Invitation for Bid

IFB-4835-20-DH

Grand Junction Public Safety Facilities Renovation (Re-Bid)

WALL TYPES

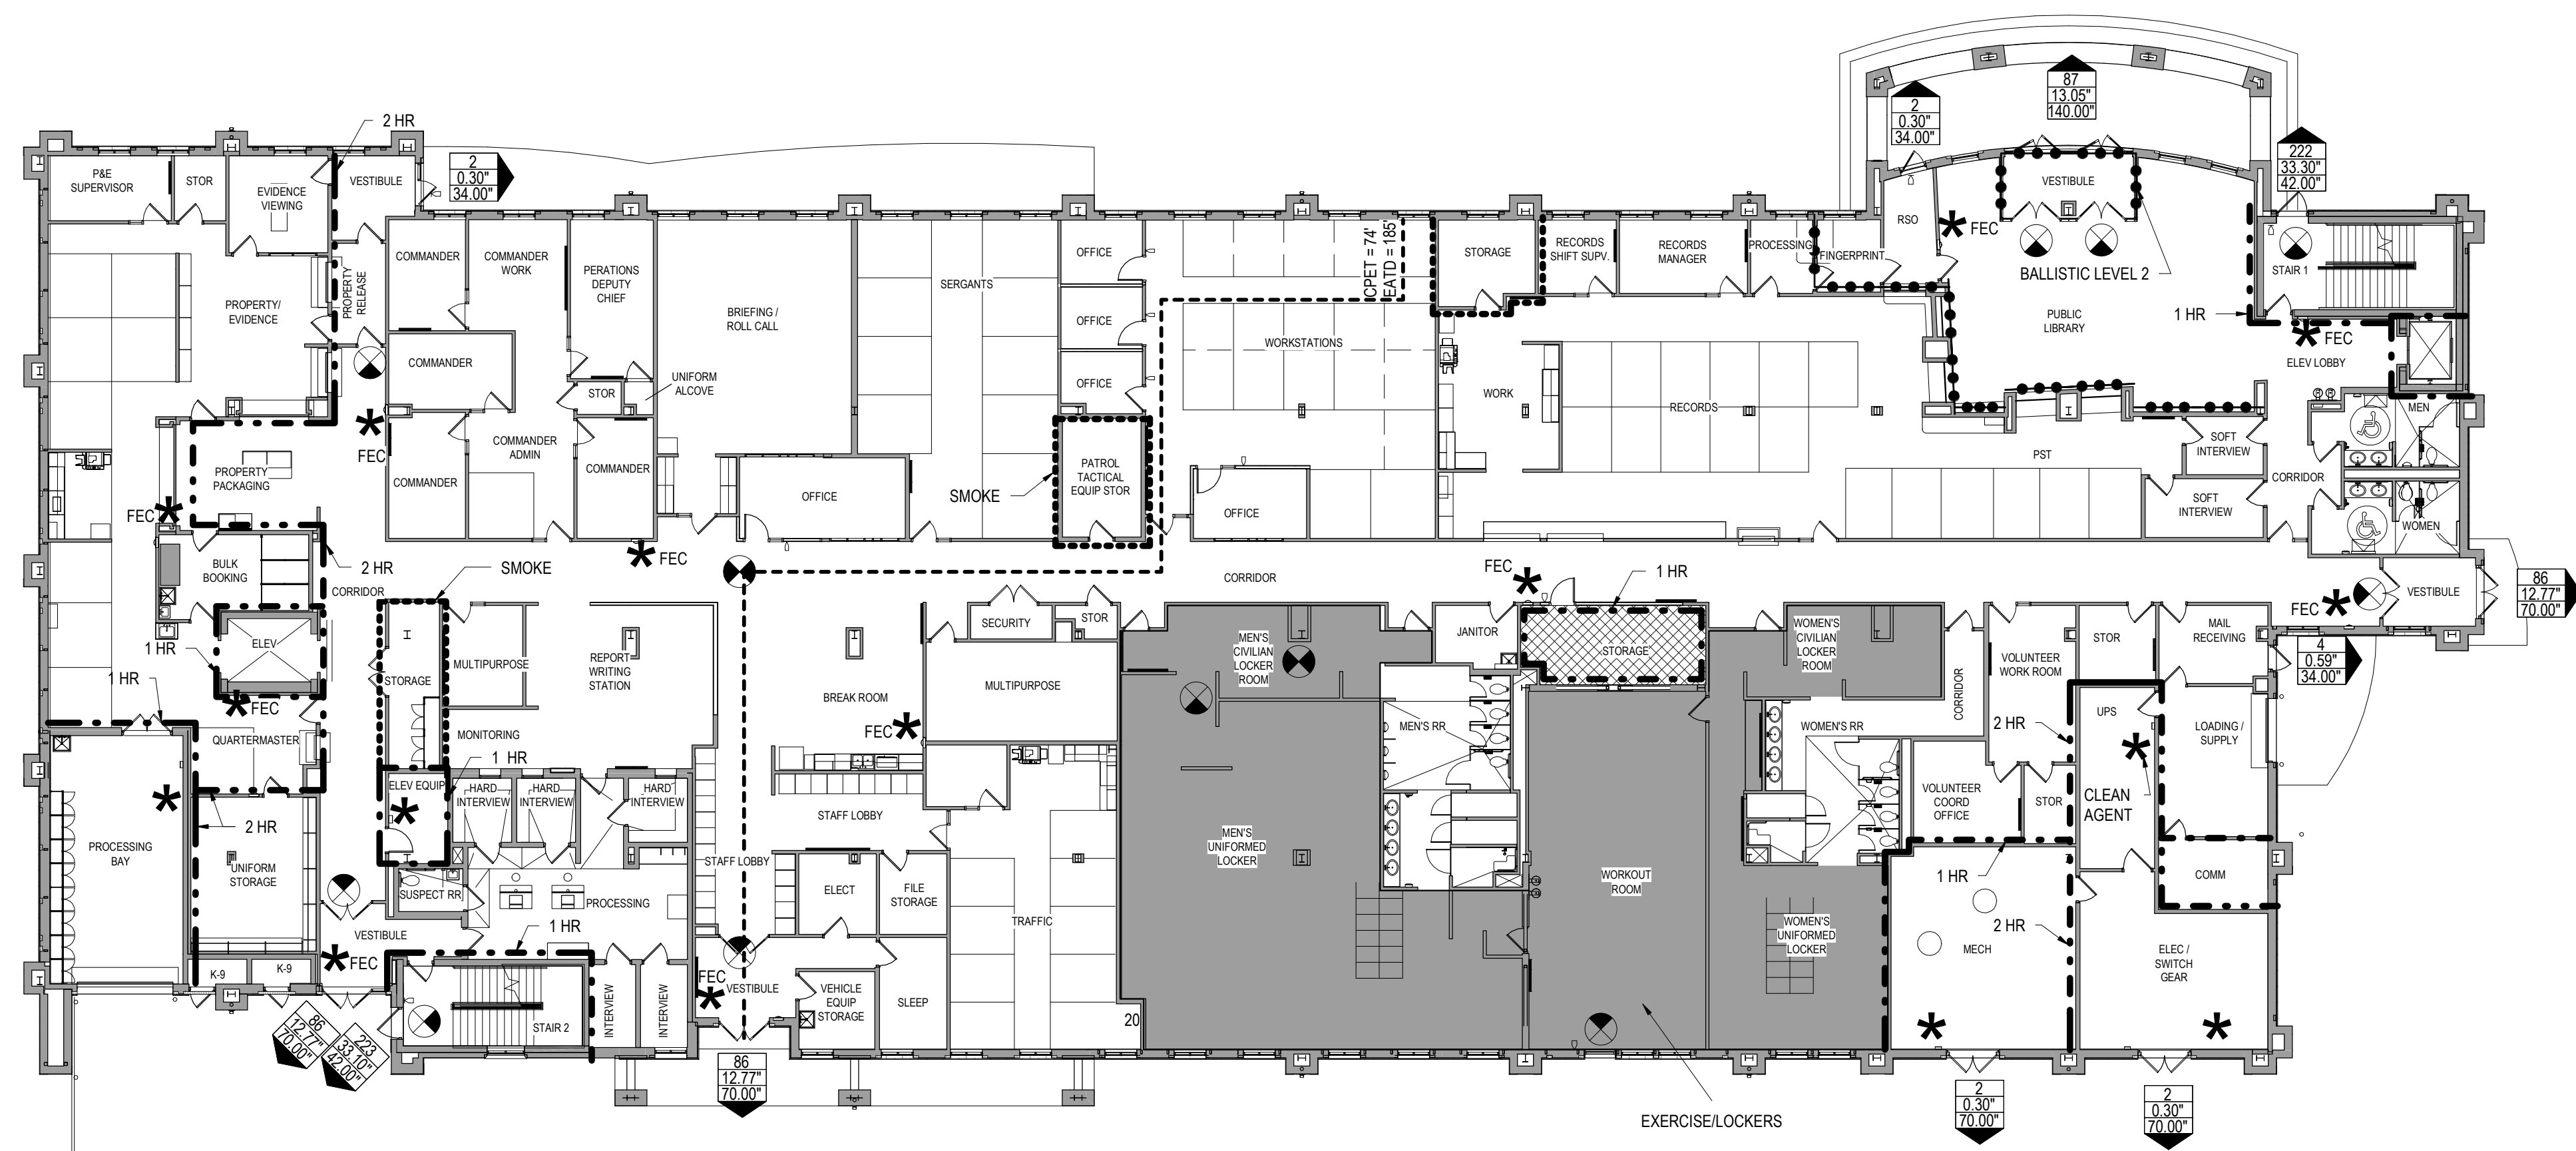
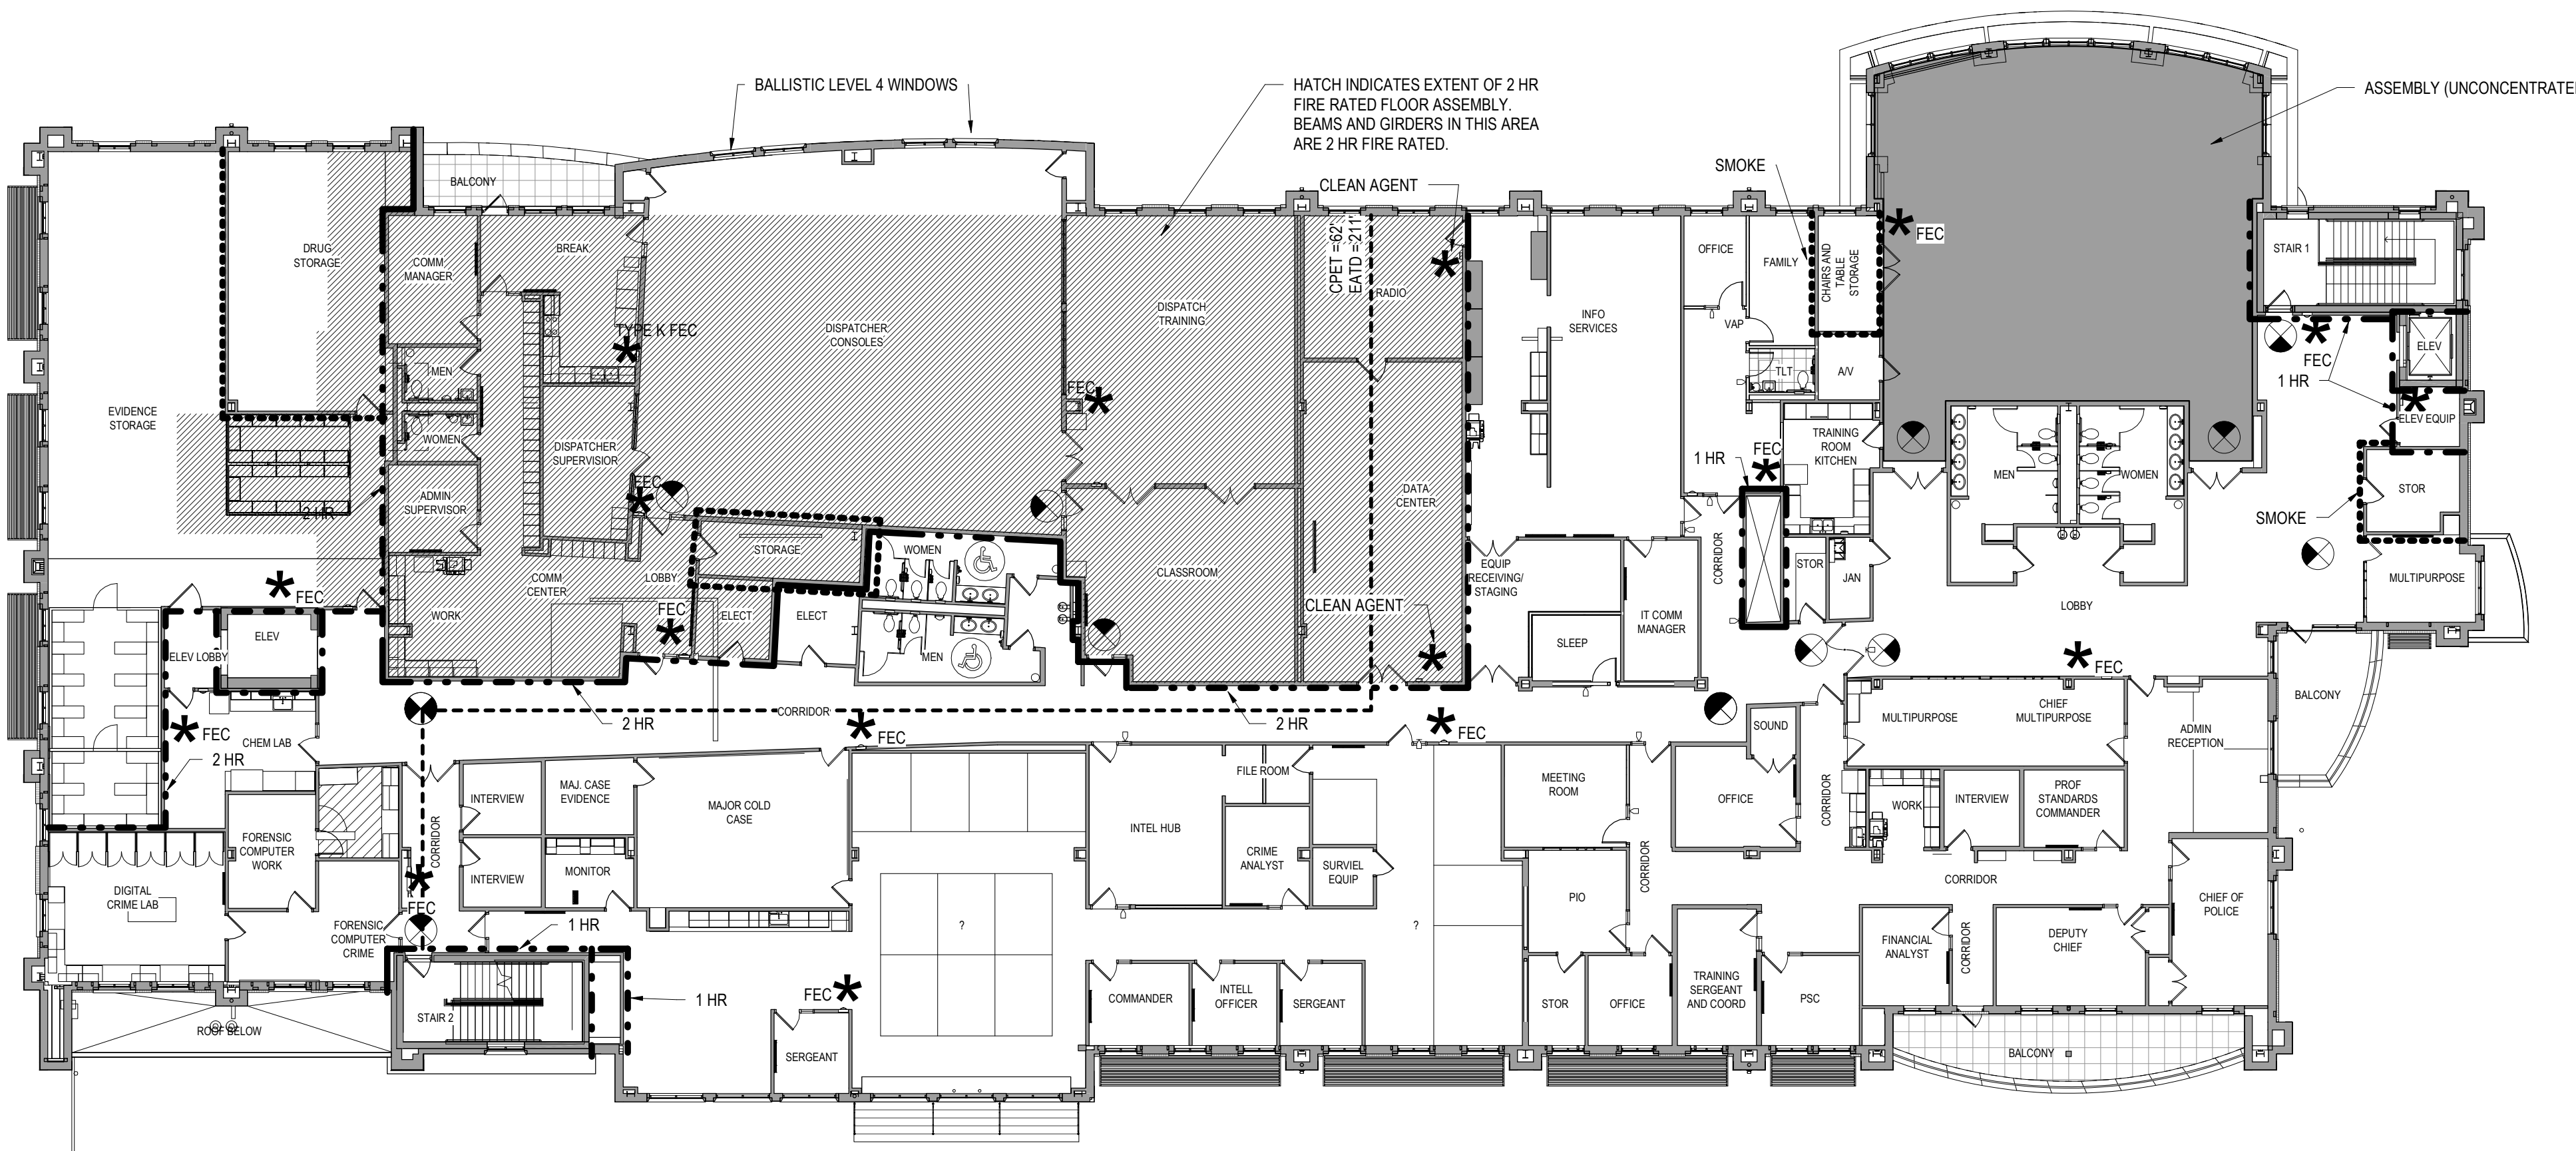
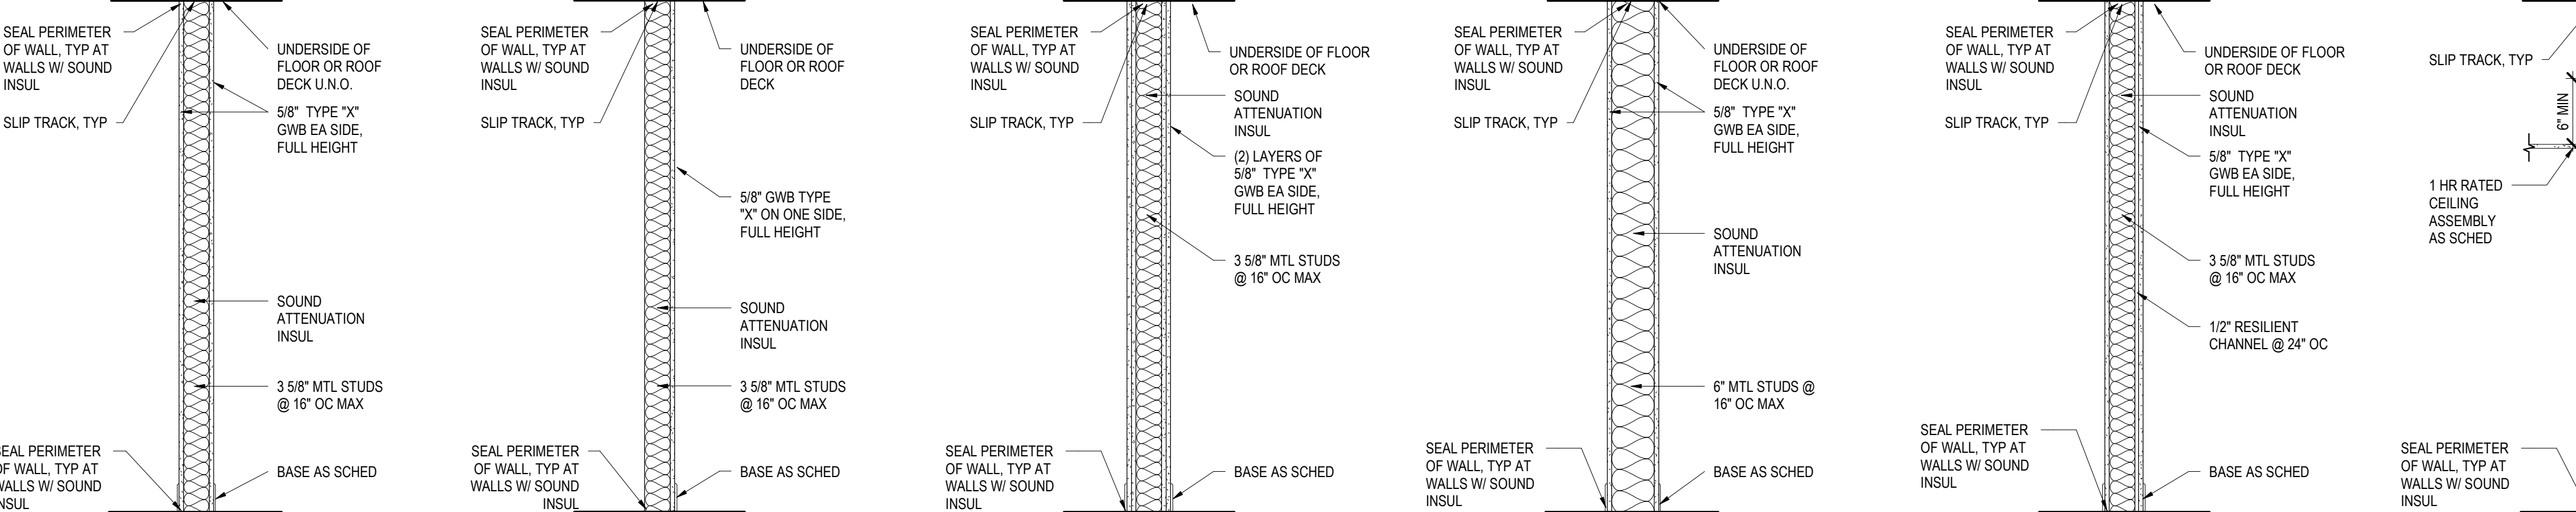
K. Q. Sheet A1-1 Key note 09-17 requires the contractor to confirm that the existing perimeter wall condition and modify as necessary to meet wall type 8. For apples to apples bidding purposes what work is anticipated on these walls to meet this requirement?

L. Q. Do walls of the ammo storage room need to be constructed to meet a 1 HR fire rating from floor to underside of the floor deck above or just to 6" above the 1 HR horizontal assembly as shown on Sheet G1-1 wall type detail number 8?

A. Walls surrounding the ammunition room are to be 1-hour rated and meet the requirements of UL listing U419 and wall type 8, as shown on sheet G1-1. The existing walls are anticipated to be constructed of 3 5/8" mtl studs w/ 5/8" gypsum wall board on ea side to the floor deck above. Note any existing wall penetrations will need to be modified to meet rating requirements.

A. The 1 hour rated walls surrounding the ammunition storage room are to be rated to 6" above the new 1 hour rated ceiling per wall type 8 on sheet G1-1.
